PCD File # COM246

Subj: Letter of Intent

PROJECT NAME:
**RCH VALLEY
 875 VALLEY STREET
 RCH VALLEY SITE/DEMOLITION PLAN**

SHEET:
C-1

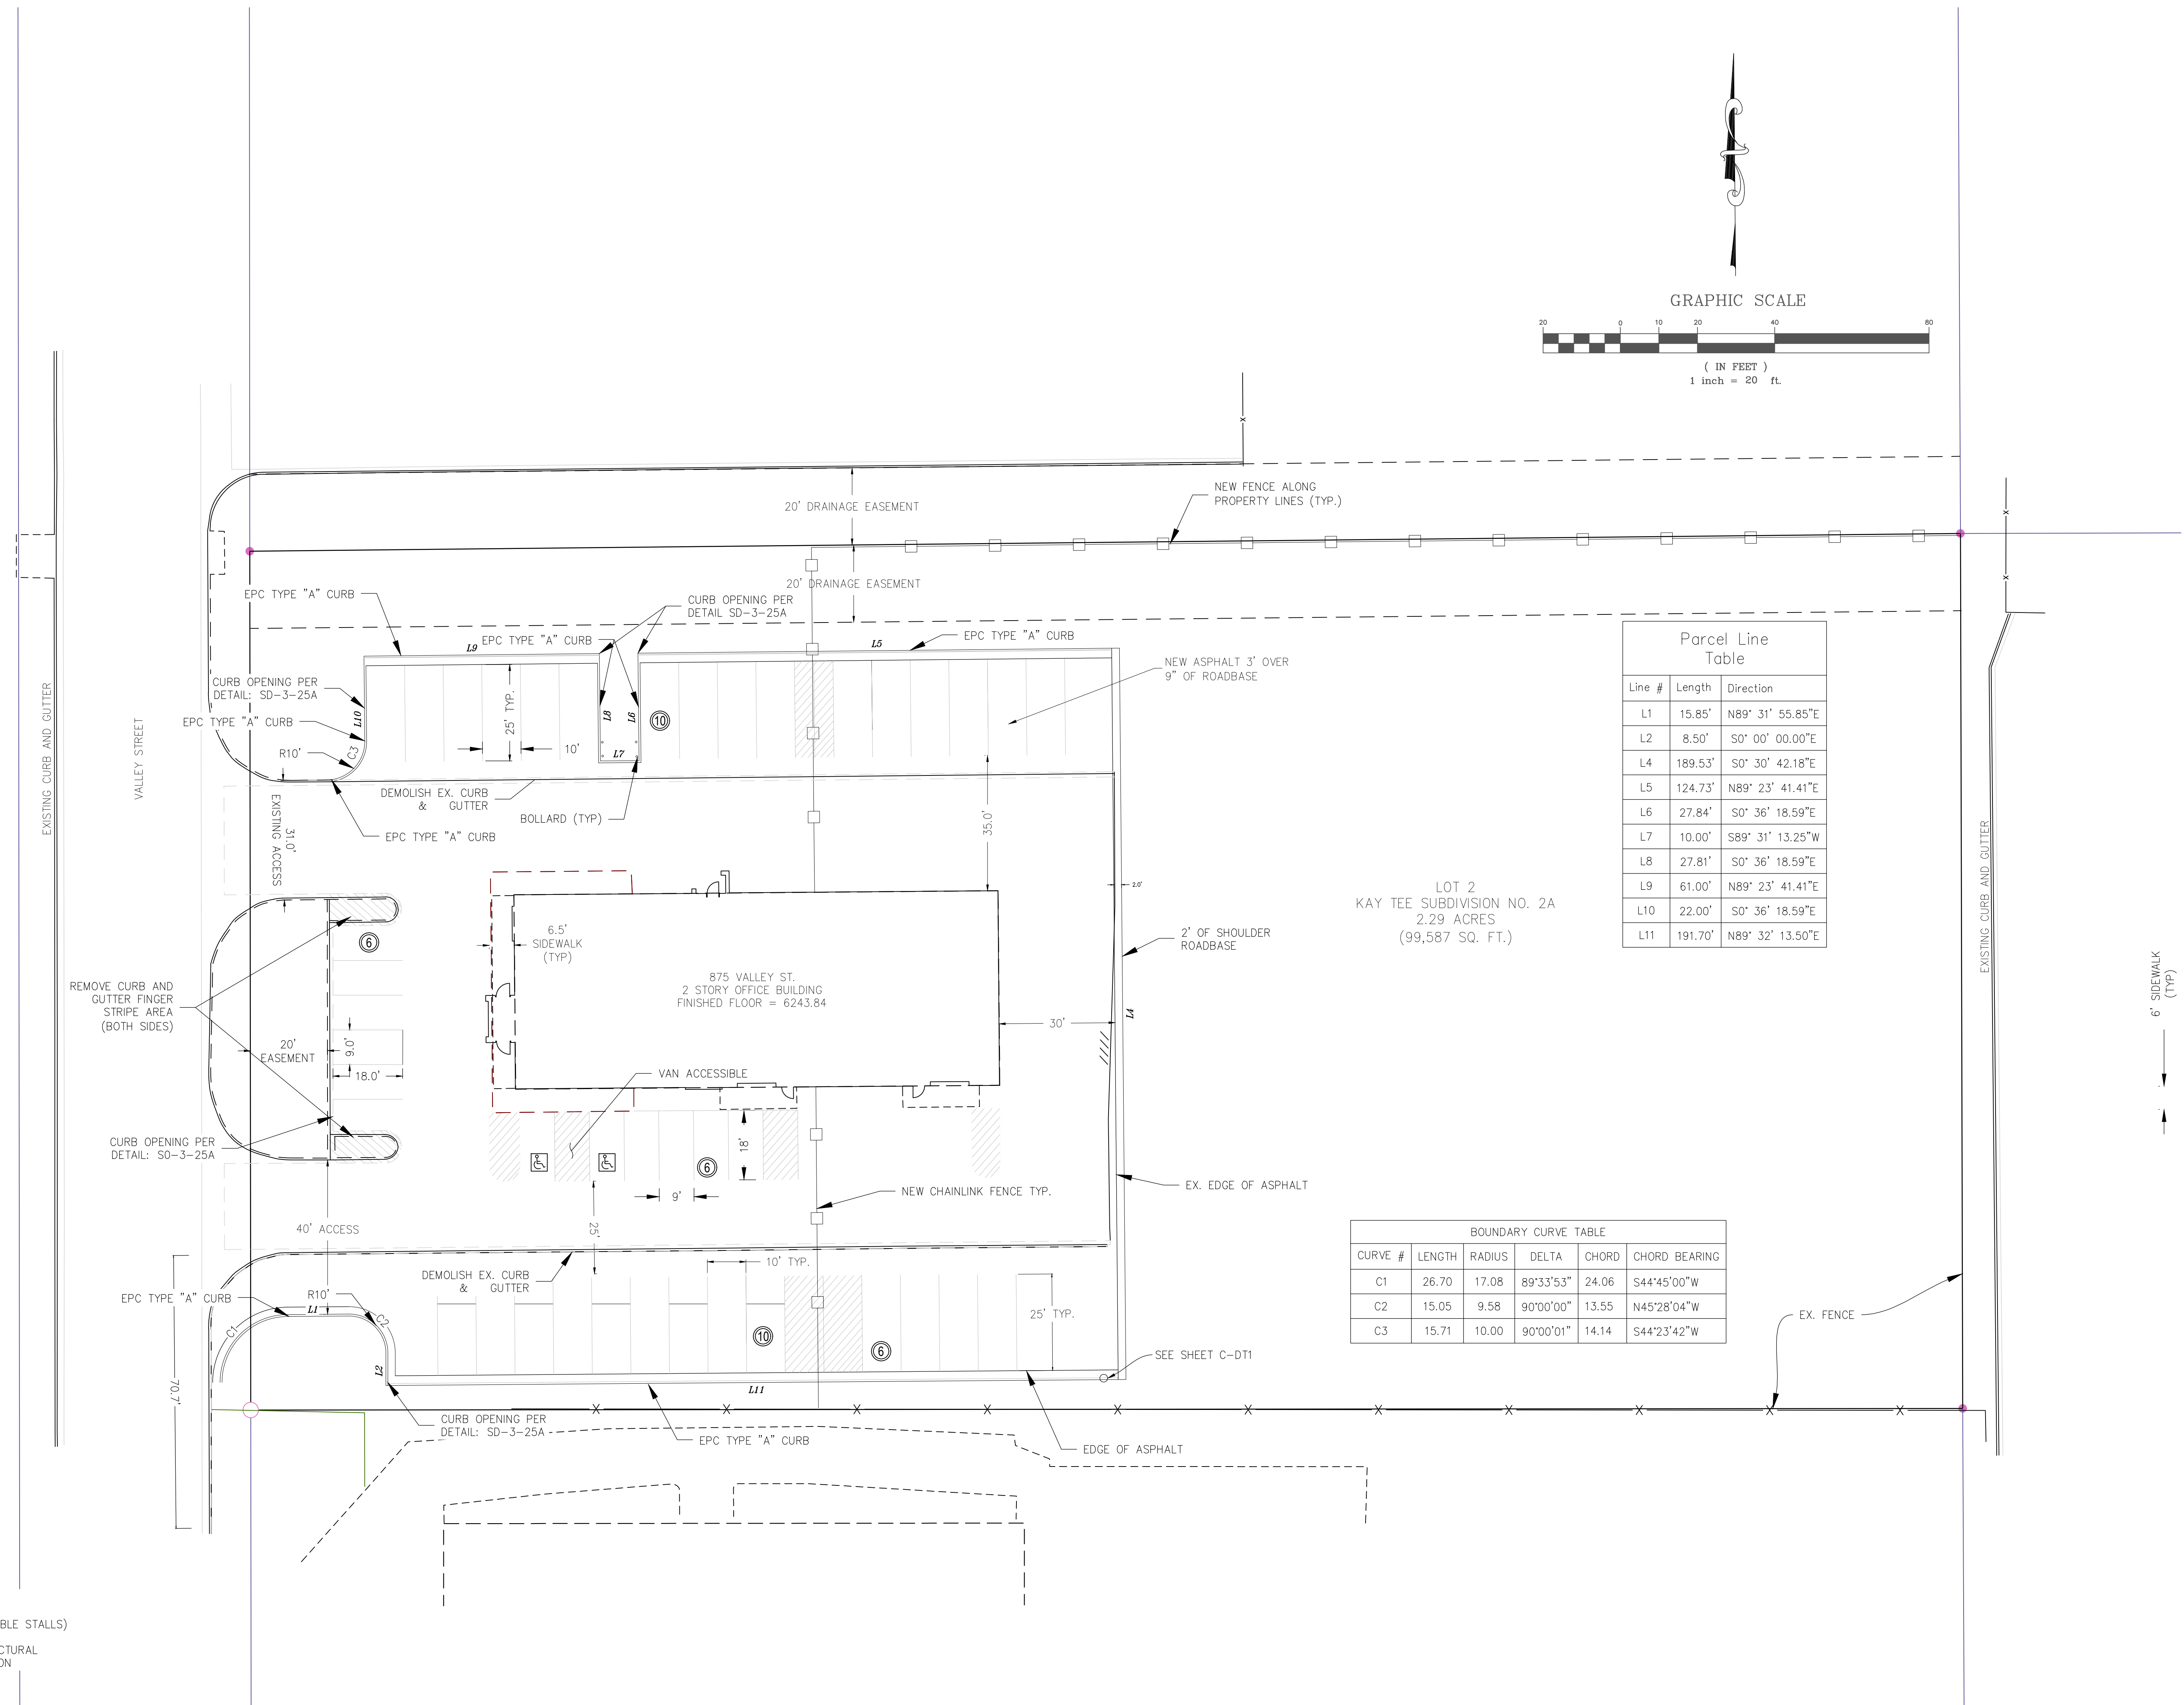
Please provide a drainage letter that provides analysis of the drainage and site flows on the lot and include pond details See DCM Vol 1 Chpt 4 Section 4.5

Please provide explanation for the 40ft entrance width on south end entrance. What type of vehicle traffic does this support.
